Access Compliance Report Public Rights-of-Way (Curb Ramps)

Intersection ID: 52590	Main Street: NOBLES_AV	Cross Street: TRIUMPH_DR	Location: SW
ADA ID: 2B2FB8841F58	Ramp Type: Para	Initial Pass/Fail: Fail	Overall Compliance: No Severity Score: 30

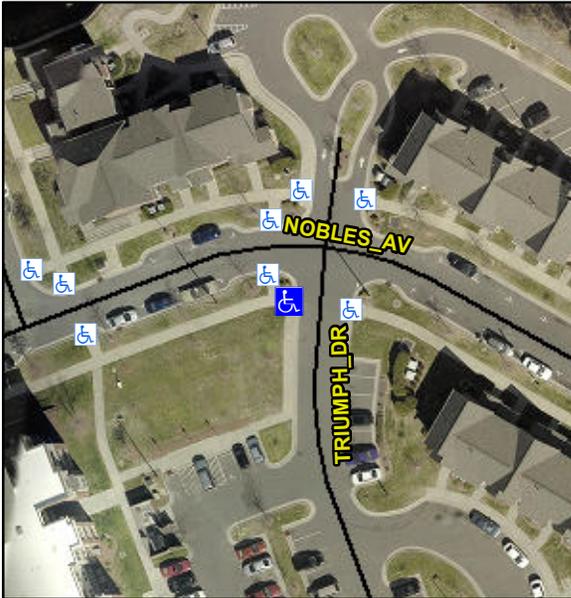
RT RP < 5%

R304.5.1, R304.3.2

Compliance	Description	Data	Compliance	Description	Data
N/A	Ramp Length LT (in)	62.0	N/A	Ramp Length RT (in)	70.0
No	Ramp Width LT (in)	36.0	No	Ramp Width RT (in)	34.0
No	Ramp Slope LT (%)	8.5	Yes	Ramp Slope RT (%)	3.9
Yes	Ramp XSlope LT (%)	0.3	Yes	Ramp XSlope RT (%)	1.7
N/A	Landing Length (in)	N/A	N/A	DWS Provided?	N/A
N/A	Landing Width (in)	N/A	N/A	DWS Contrast?	N/A
N/A	Landing Slope (%)	N/A	N/A	DWS Length (in)	N/A
N/A	Landing X Slope (%)	N/A	N/A	DWS Full Width?	N/A
N/A	Landing Curb? (Y/N)	N/A	N/A	DWS Offset (in)	N/A
N/A	Shared Landing?	N/A			
N/A	Gutter Ponding?	N/A	N/A	Gutter Slope (%)	N/A
N/A	Gutter Lip Ht (in)	N/A	N/A	Gutter X Slope (%)	N/A
N/A	Painted X Walk1?	No	N/A	Painted X Walk2?	N/A
	X Walk 1 Direction	To E		X Walk 2 Direction	N/A
N/A	X Walk 1 Width (in)	N/A	N/A	X Walk 2 Width (in)	N/A
	X Walk 1 Slope (%)	5.2		X Walk 2 Slope (%)	N/A
	X Walk 1 X Slope (%)	1.2		X Walk 2 X Slope (%)	N/A
N/A	Ramp inside XWalk1?	N/A	N/A	Ramp inside XWalk2?	N/A

Remove & Replace Entire Ramp.
